Access Compliance Report Public Rights-of-Way (Curb Ramps)

Intersection ID: 11331 Main Street: E_W_T_HARRIS_BV Cross Street: MEADOW_ROSE_LN Location: NE

ADA ID: CC83804AEB1E Ramp Type: Combination1 Initial Pass/Fail: Fail Overall Compliance: No Severity Score: 18.75

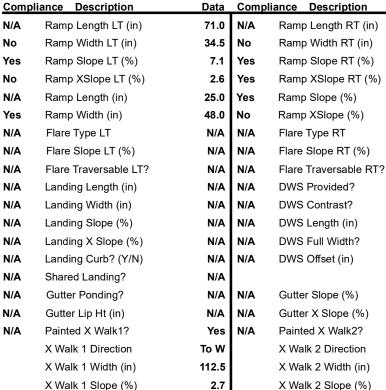
Surveyor Notes:

RT RP < 5%

PROW/ADA:

Not Found, R304.5.1, R304.5.3

Possible Solutions:

Remove & Replace Entire Ramp.
